Construction Division
Additions & Alteration Charges Approval Form

MAYFLOWER PLATINUM

Details of Additions & Alterations

Flat No	401	Block	'C' ✓
Flat Area	1500 sft	Type	Deluxe / Luxury
Buyer Name	Mrs.K Karunasree/Mr.P.R.Venkat T Rao		
Phone No.	9391029842/7680000439	Email	karuna.shree@gmail.com

ELECTRICAL PLAN OF FLAT-CI

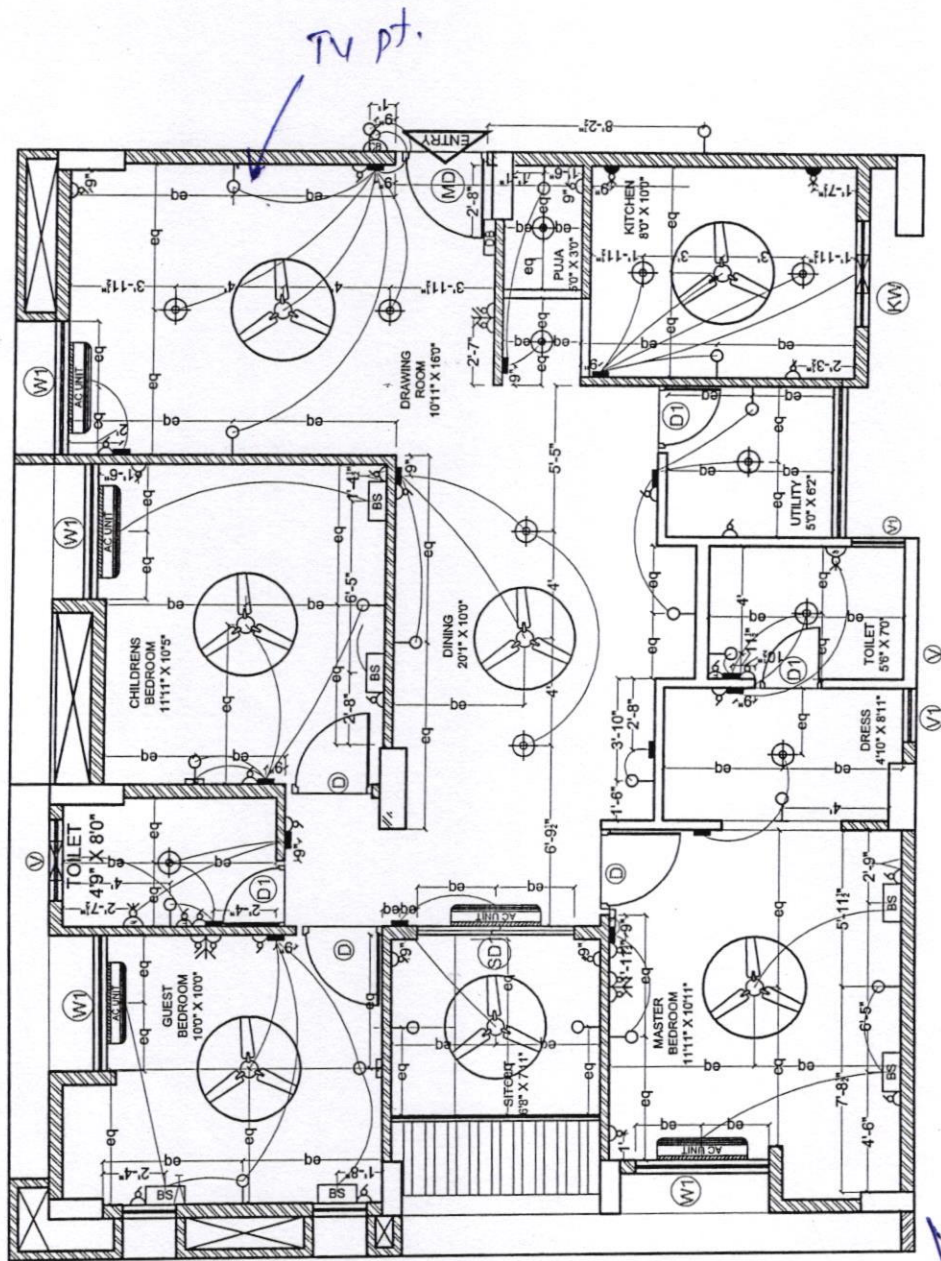
Changes in electrical points: (mark on plan)

① Marked on plan
